GRP/EPOXY

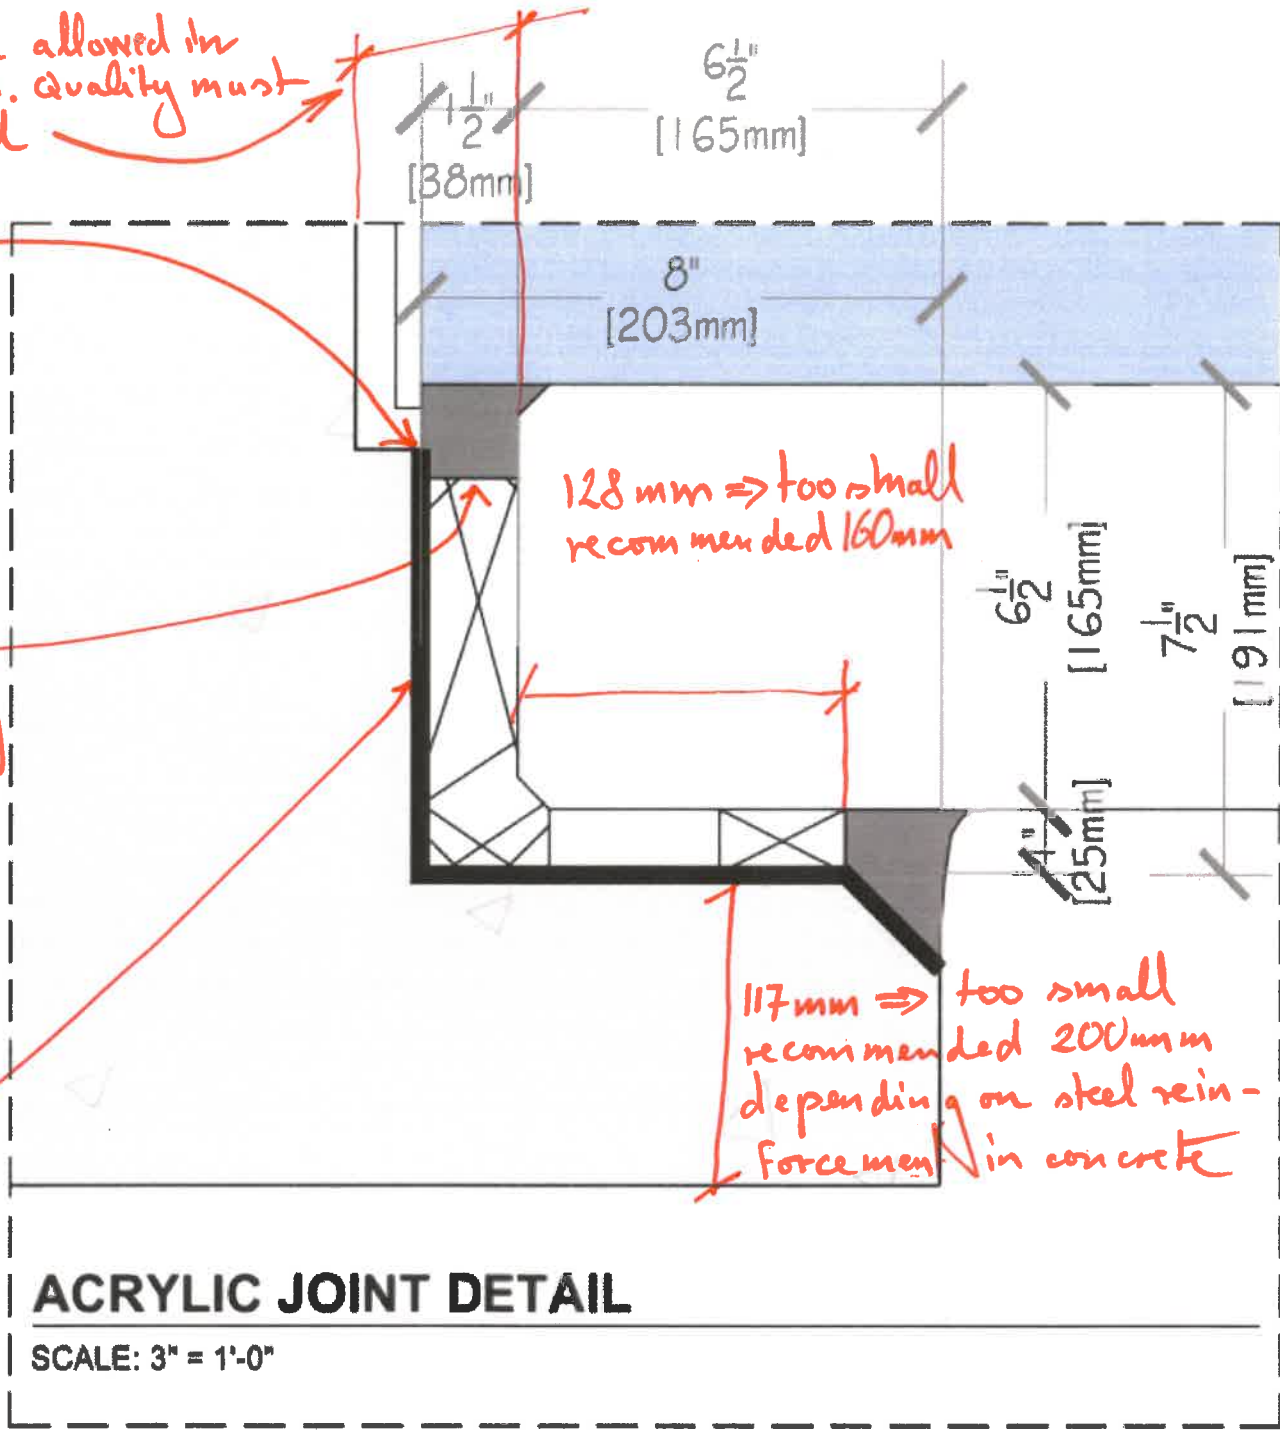
Absolutely no tolerance allowed in concrete dimensions. Quality must be of highest standard

Undefined:
Water can penetrate behind the epoxy layer

Silicone seal on site

- No safety reserve during water testing. Testing only carried out using existing water pressure
- No pressure testing possible for later injection/maintenance

- Adhesion of silicone to the epoxy fibre glass coating has been proven to be less durable than to stainless steel
- GRP is not crack-bridging, which can lead to leaks when the concrete settles.
